DOCKETED	
Docket Number:	20-SPPE-02
Project Title:	Lafayette Backup Generating Facility
TN #:	252347
Document Title:	Digital Realty Comments on the DEIR regarding Monitoring Well 3
Description:	N/A
Filer:	Scott Galati
Organization:	DayZenLLC
Submitter Role:	Applicant Representative
Submission Date:	9/22/2023 8:44:49 AM
Docketed Date:	9/22/2023

Application For Small Power Plant
Exemption for the **LAFAYETTE
BACKUP GENERATING FACILITY**

**DIGITAL REALTY RESPONSE TO
VALLEY WATER COMMENTS ON
THE DRAFT ENVIRONMENTAL
IMPACT REPORT**

Apparent Edge
of Grouted
Well

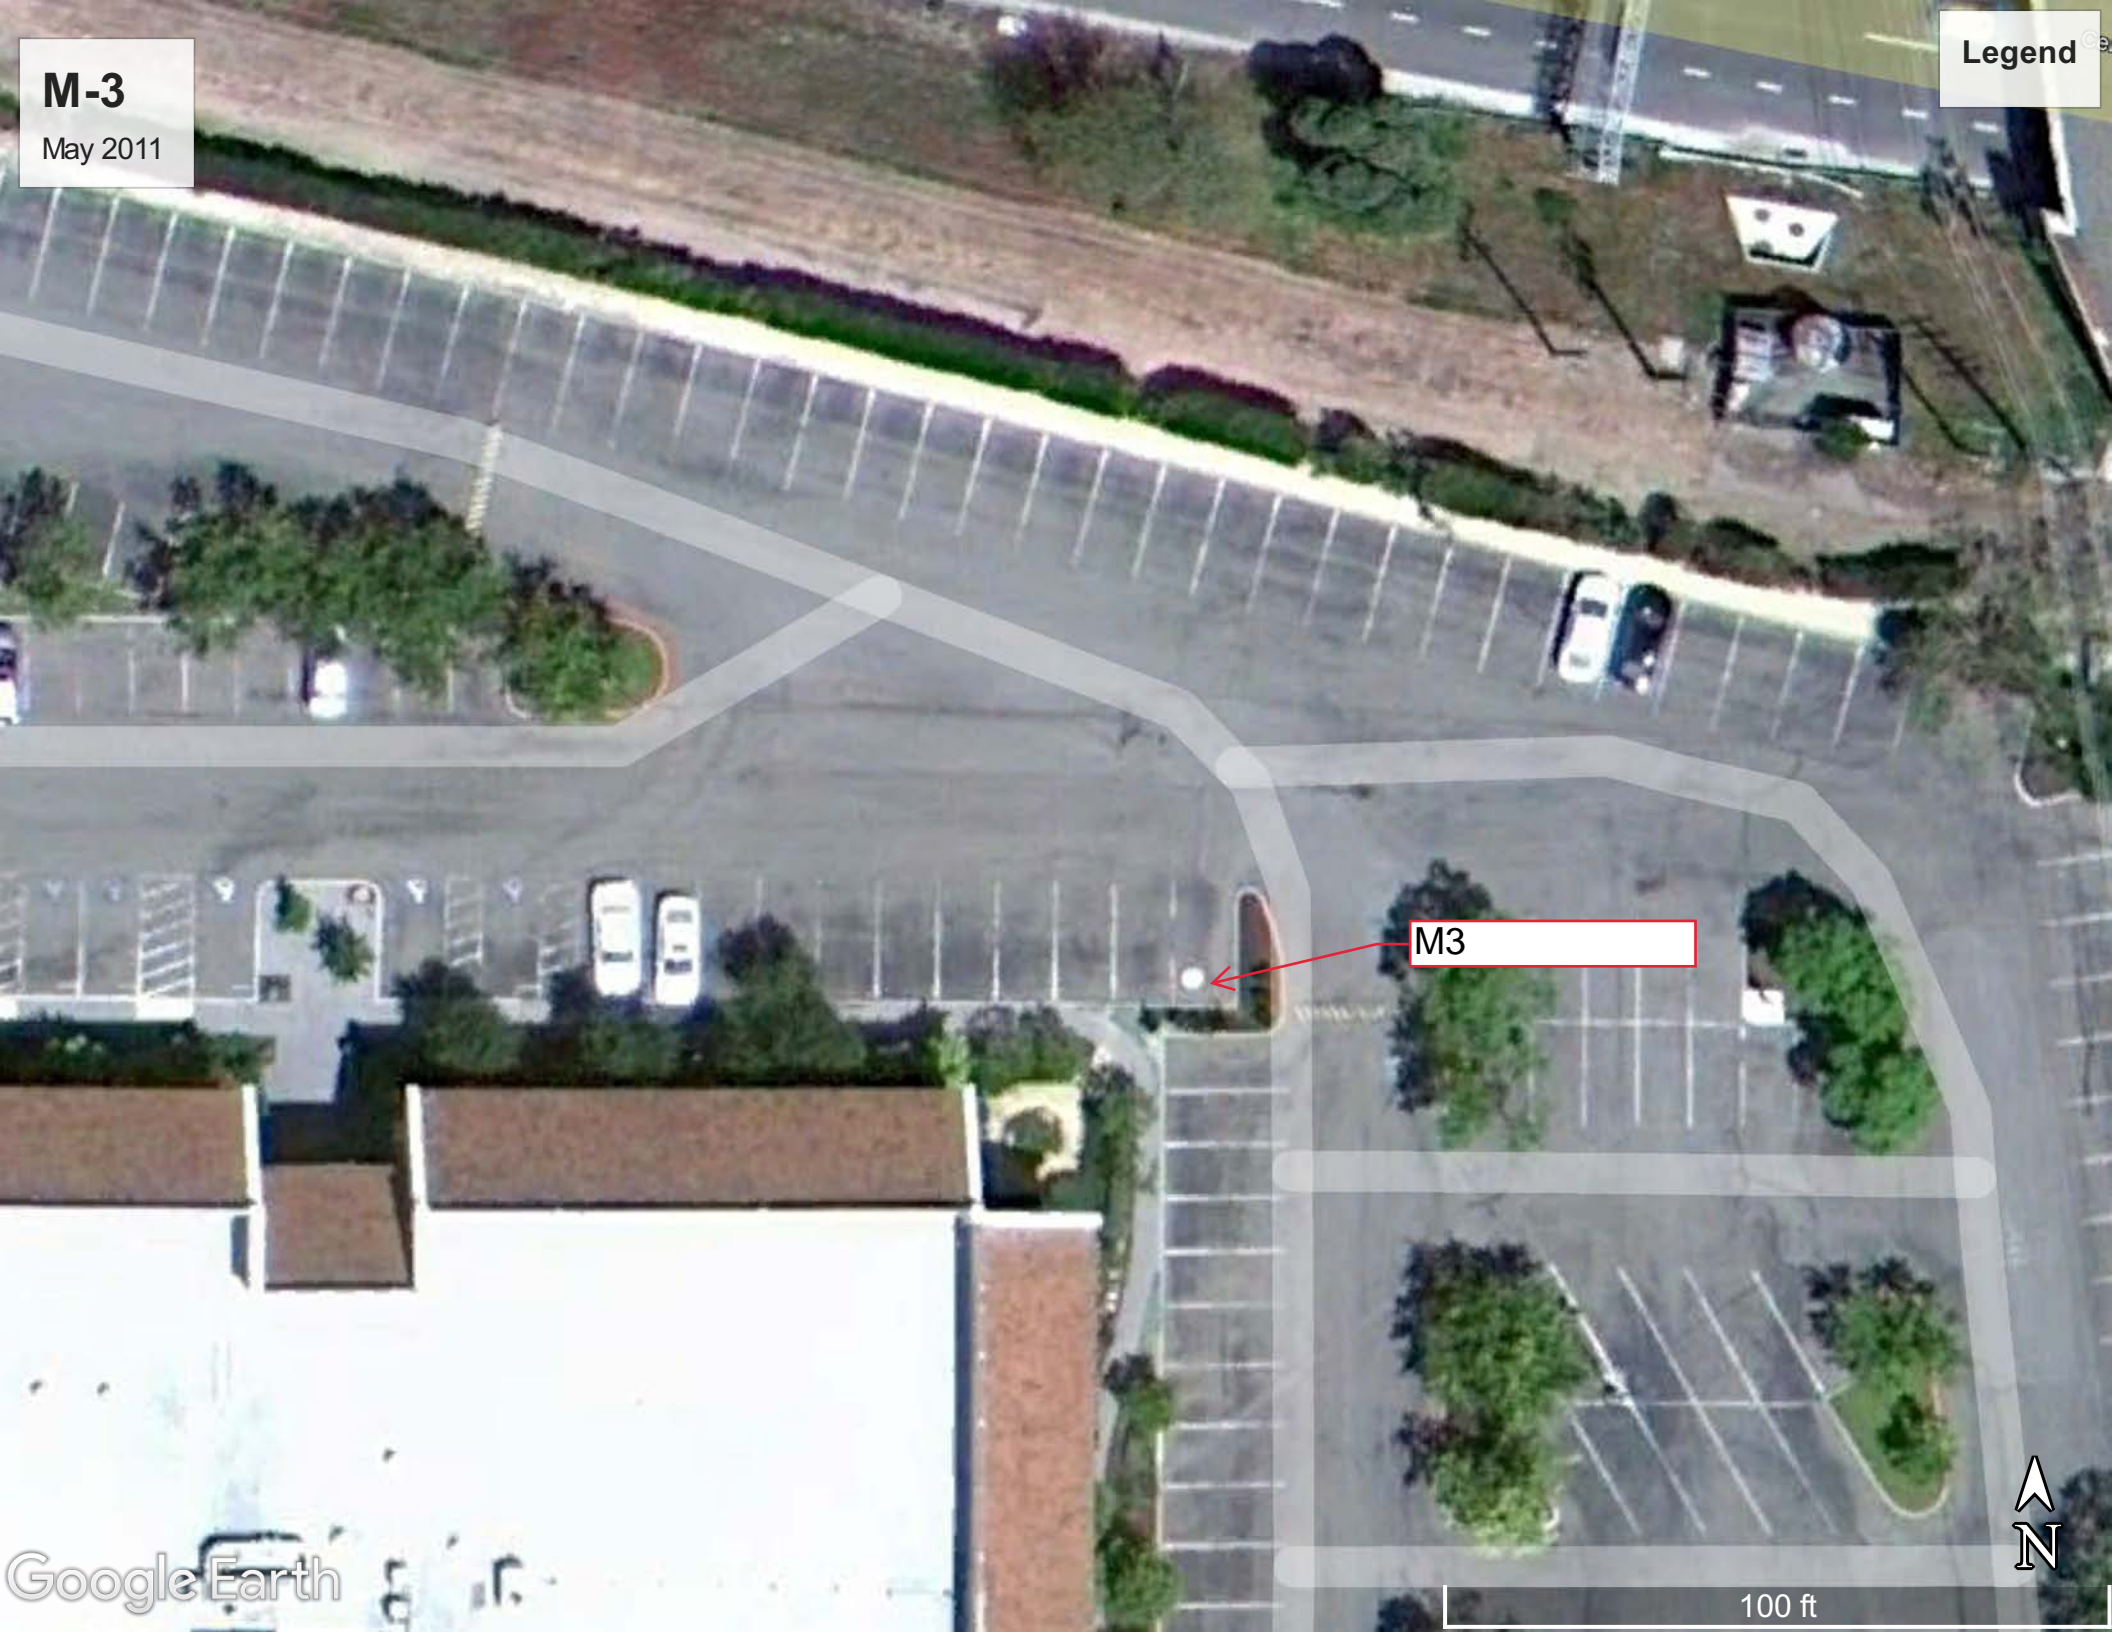
Digital Realty engaged Rosso Environmental to locate and, if possible, report on the condition of Monitoring Well 3. Rosso Environmental researched historical aerial photographs and conducted a site visit. In summary, groundwater monitoring well M-3 was installed in 1986 and was likely covered with new asphalt by 2004 and was not found by consultants in 2004 and 2005 as noted in the 2005 RWQCB NFA letter, attached. Based on Aerial Photographs, evidence of the abandonment/destruction of M-3 is evident by 2011. Rosso Environmental located Monitoring Well 3 and discovered residual grout

on the ground surface typically associated with a destroyed groundwater monitoring well remains in the location of M-3 (see M3 Photos).

Digital Realty understands that in order to comply with existing laws, ordinances, regulations and standards, it must ensure that the Monitoring Well 3 is properly abandoned and destroyed. Digital Realty will properly abandon Monitoring Well 3 in accordance with applicable LORS and provide a report to the City of Santa Clara and Valley Water prior to construction of the LBGF.
